Access Compliance Report

Public Rights-of-Way

(Curb Ramps)

Intersection ID: 31403	Main Street: BITTERROOT_CT	Cross Street: BRAWER_FARM_DR	Location: E
ADA ID: 8874860ACE74	Ramp Type: PerpDiag	Initial Pass/Fail: Fail	Overall Compliance: No
			Severity Score: 13.75

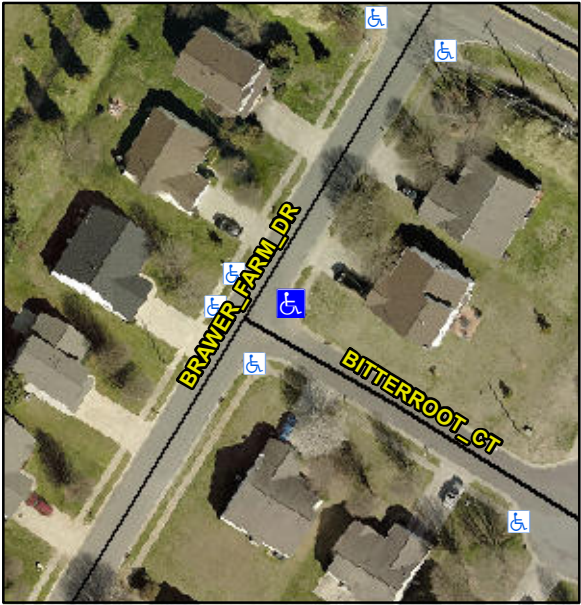
Codes/Mitigation Info/Possible Solution			Field Measurements/Component Compliance		
	Possible Solutions:		Compliance	Description	Data
	Remove & Replace Curb Ramp With Two New Directional Ramps or Equivalent.		No	Ramp Length (in)	48.5
			Yes	Ramp Width (in)	48.0
			N/A	Flare Type LT	N/A
			N/A	Flare Slope LT (%)	N/A
			N/A	Flare Traversable LT?	N/A
			N/A	Landing Length (in)	N/A
			N/A	Landing Width (in)	N/A
			N/A	Landing Slope (%)	N/A
			N/A	Landing X Slope (%)	N/A
<p>Surveyor Notes:</p> <p>N/A</p>			N/A	Landing Curb? (Y/N)	N/A
			N/A	Shared Landing?	N/A
			N/A	Gutter Ponding?	N/A
			N/A	Gutter Lip Ht (in)	N/A
			No	Painted X Walk1?	N/A
			To N	X Walk 1 Direction	N/A
			N/A	X Walk 1 Width (in)	N/A

6.2	X Walk 1 Slope (%)	N/A
			3.2	X Walk 1 X Slope (%)	N/A
			N/A	Ramp inside XWalk1?	N/A
<p>PROW/ADA:</p> <p>R304.2.2, R304.5.3</p>			N/A	Road Slope (%)	N/A
